# Design Process Review

Documented Revisions of Waste Sorter Project
Gavin Lusby & Jaydan Law

Schematic Diagram Revision 1, 11/10/2022

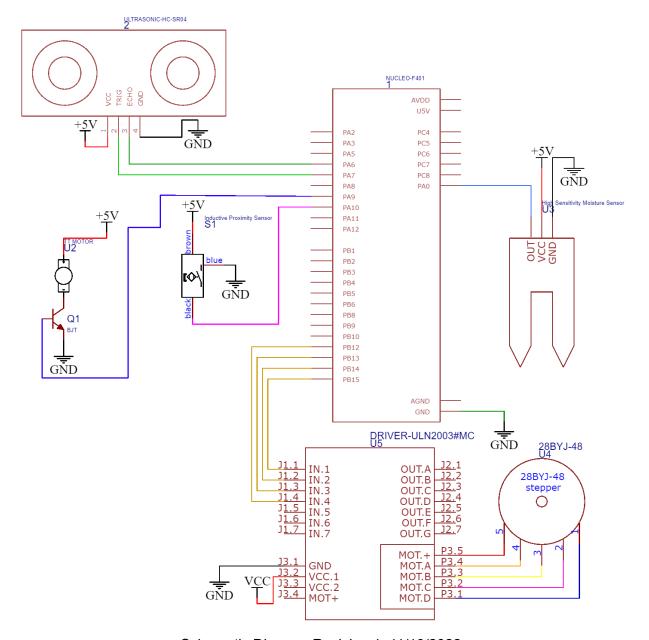
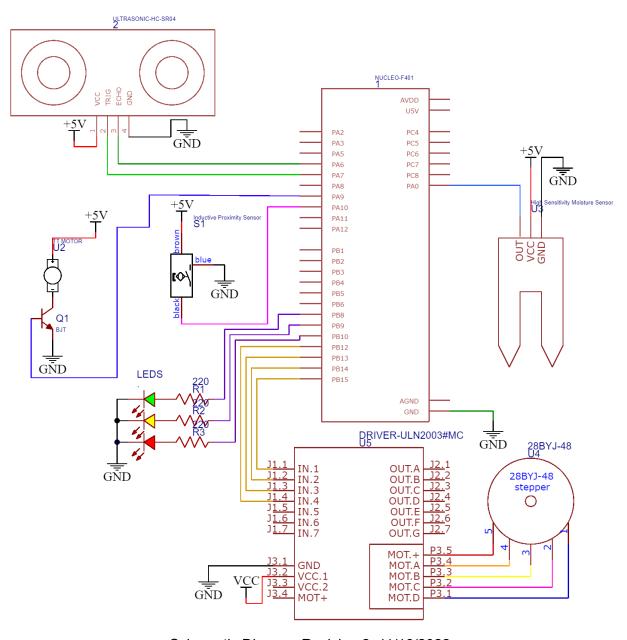
This change had two purposes:

- Remove one TT Motor from Schematic Diagram to be consistent with mechanical drawings
- 2) Replace Servo Motor controlling collection plate with Stepper Motor. We realized our original design required a servo motor encoder in order to detect rotation, position, distance, which we realized we did not possess. Without this, we would only be able to apply a certain amount of torque without knowing how much it rotates the motor(eg. If

the plate fills up, it weighs more, so now when you apply a certain amount of torque it doesn't rotate as much). We opted to switch for a stepper motor with a ULN2003 Motor Driver because we were able to find those materials, and also, we could easily tell the position of a stepper motor and assign each sorting compartment it's own rotational coordinate(eg. Rotate 90deg to get from compartment A to compartment B, rotate -90deg to get from compartment B).

The purpose of this change was simple. We wanted visual indicators to show which section the trash is being sorted into. The addition we made was hooking up 3 LEDs, one for each type of disposable item (metals, organics, and other). We will hook up these 3 LEDs to GPIO pins and the corresponding LED will turn on for two seconds after the item falls in the basket to indicate what type of waste it would be sorted as.

Main Chassis Revision 1, 11/10/2022

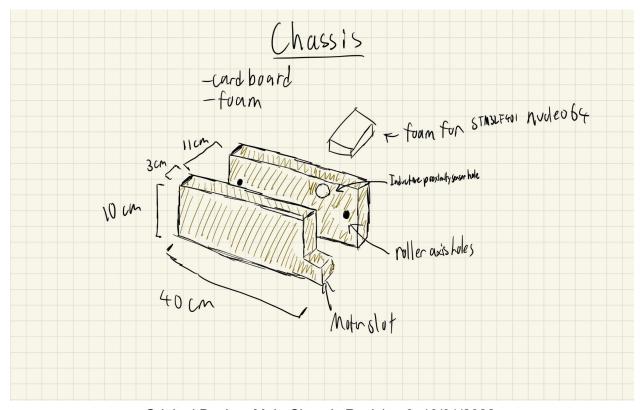
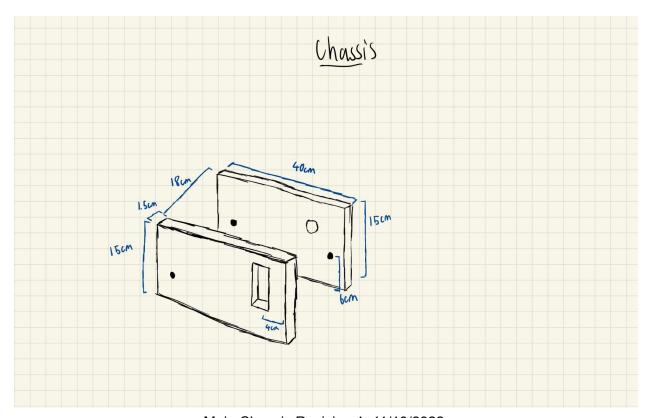
This revision includes multiple changes.

- 1) The holes for the conveyor roller supports were moved farther apart, as the conveyor belt was not wound tightly enough around the wheels (Moved 1 cm further apart)

- 2) The holes for the conveyor belt were moved up (1 cm) as the conveyor belt was dragging on the ground
- 3) The motor driving the conveyor belt was shifted 4 cm inward. This allows us to secure it into the cardboard on four sides rather than just two as originally intended. This will help with the stability of the conveyor belt

- 4) The height of the walls of the chassis were increased by 5 cm to allow for more space to accommodate for the conveyor belt and sensors that will be installed

- 5) The thickness of the walls was decreased by 1.5 cm to eliminate unnecessary bulk and size
- 6) The spacing between the walls was increased by 3 cm to allow for less contact of the belt with the walls which was causing unnecessary friction

Main Chassis Revision 2, 11/16/2022

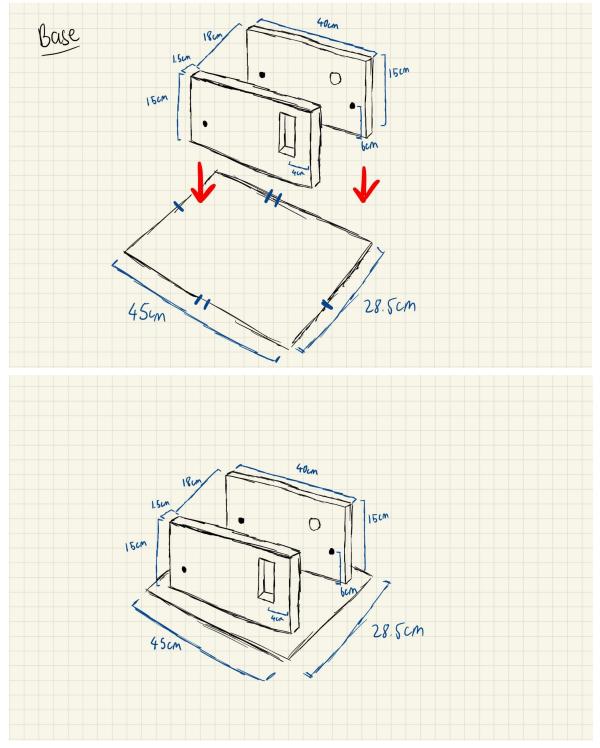
This iteration introduced the new addition of a base plate. The purpose of the base plate is to add stability to the machine, as the conveyor belt would cause movements in the entire

machine. By adding the base plate, this distributes the weight evenly and adds weight to the bottom, anchoring our machine and counteracting the movements of the conveyor belt.

Collection/Rotating Plate Revision 1, 11/10/2022

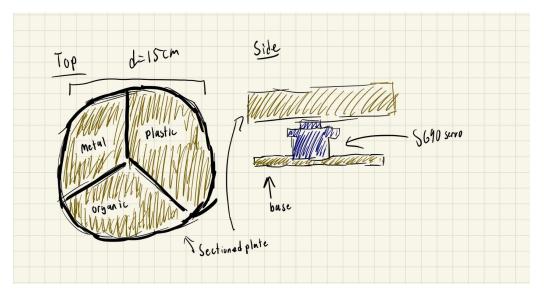
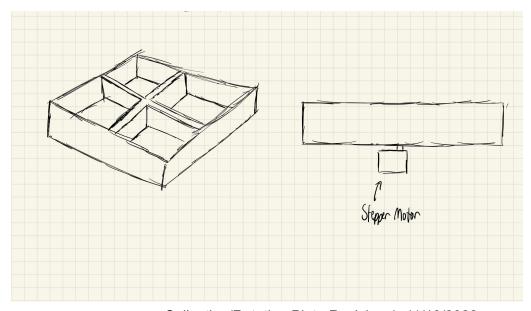
Two changes were made in this revision. The first one is the shape of the plate itself, which was initially a circle with 3 sections but is now a square with 4 sections. The reason for this was ease of manufacturing, a circular design is more complicated to produce compared to the square. As well, the sections were increased but only 3 are still actually in use, the fourth section is only there for balancing purposes. The second change was the change in motor, going from a Servo SG90 to a Stepper Motor. We realized our original design required a servo motor encoder in order to detect rotation, position, distance, which we realized we did not possess. Without this, we would only be able to apply a certain amount of torque without knowing how much it rotates the motor(eg. If the plate fills up, it weighs more, so now when you apply a certain amount of torque it doesn't rotate as much).

Side Wall Revision 1, 11/10/2022

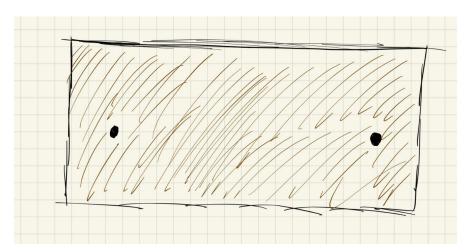
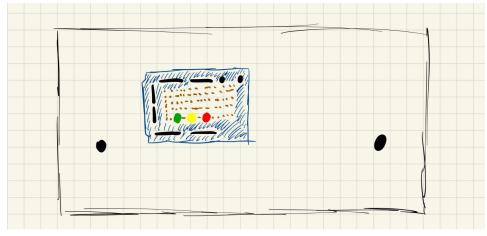
The changes made in this iteration were the addition of the proto-board to the side of the outer wall as well as indicator LEDs. The protoboard is simply for connections, and the LEDs are there to visually indicate what category a piece of garbage is sorted into when passing through the machine and sensors.
